PROJECT:	2020 EDCOUCH STREET IMPROVEMENTS PROJECT	REVISED DATE:	5/24/21
	URBAN Co. PROJECT #: 5020-20-0311-5200-0000-UCP-ET	PREPARED BY:	JOSE E. "EDDIE" SAENZ, P.E.
LOCATION:	CITY OF EDCOUCH (2020)	ENGINEER'S ESTIMATE	
	ADDITIONAL ADJACENT STREETS - CHANGE ORDER No. 1	NO DESIGN	
CLIENT:	CITY OF EDCOUCH	PRELIMINARY DESIGN	
	OVERLAY PAVEMENT IMPROVEMENTS	X FINAL DESIGN

Re-Evaluation of Edcouch 2020-Street Improvements

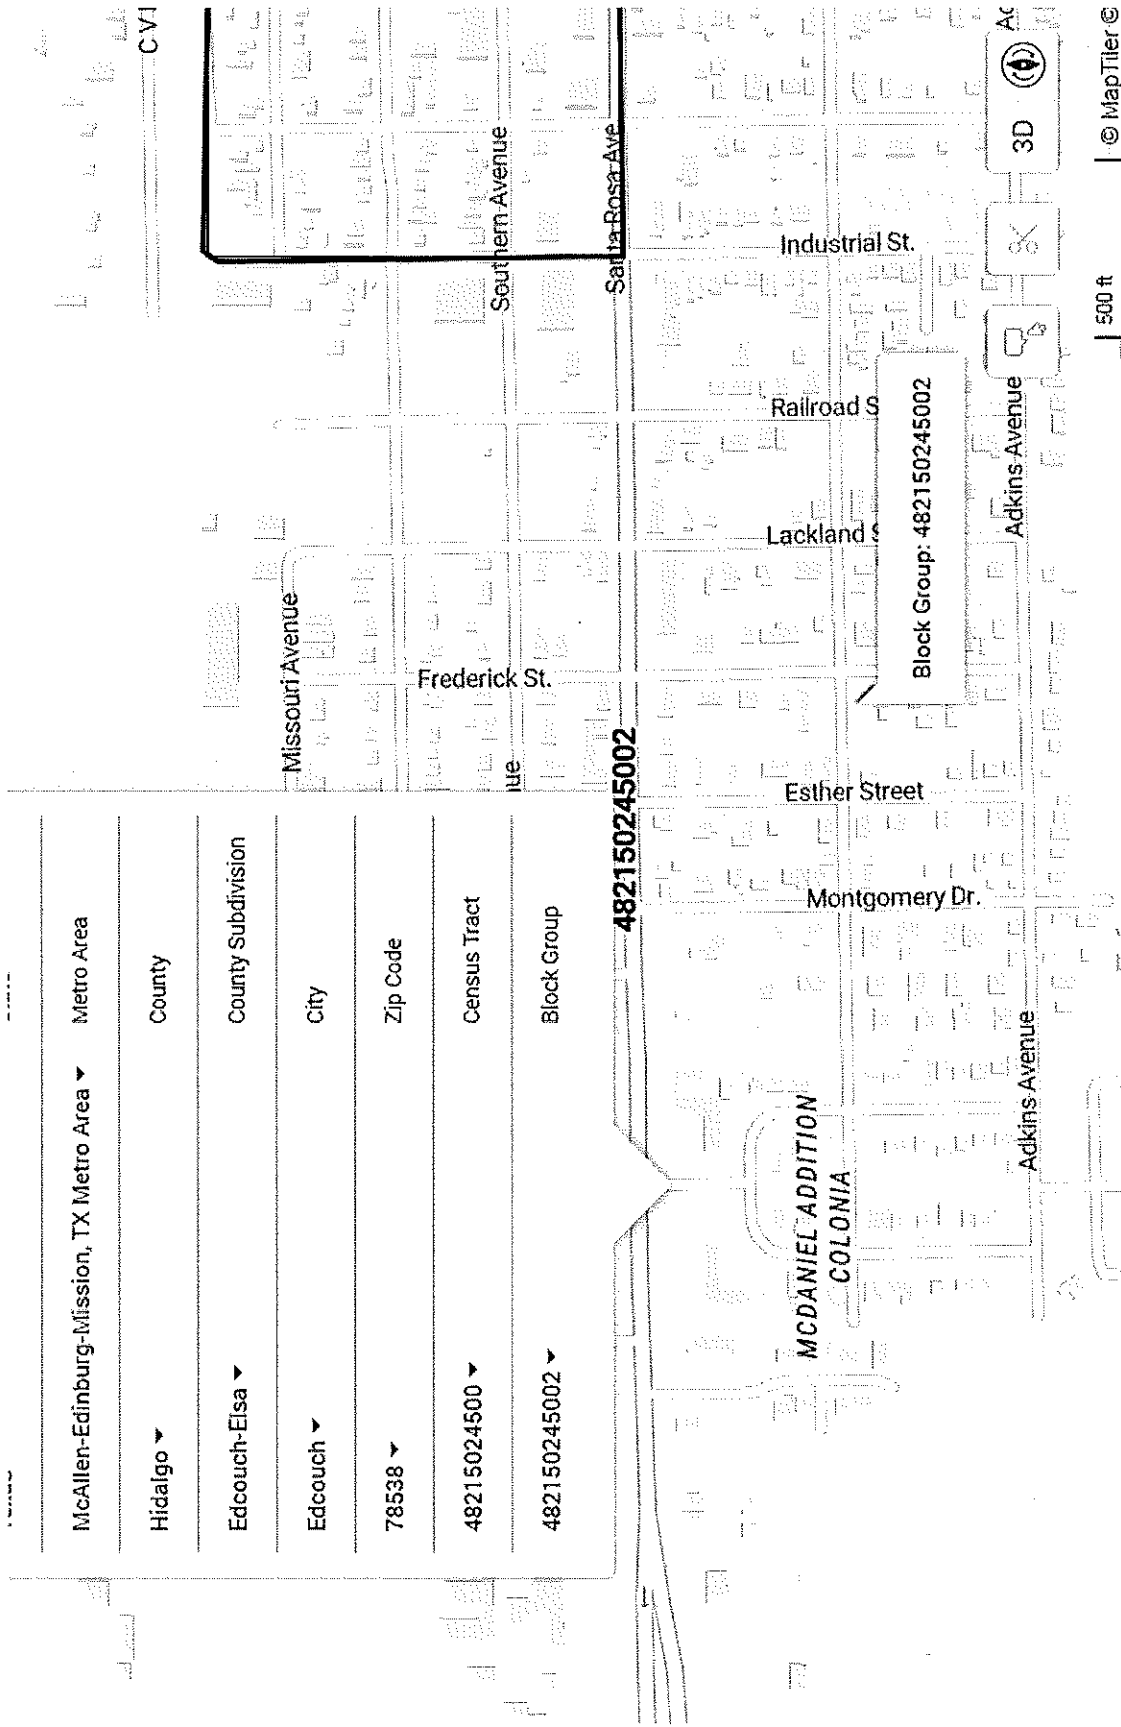
Streets in red are in the original scope of work while streets in blue (McDaniel St (from SH107 to Intersection) W. Adkins Ave. (from Montgomery St. to Dead-End) & S. Industrial St. (From W. Adkins Ave. to Crenshaw Ave.)) are the additional streets.
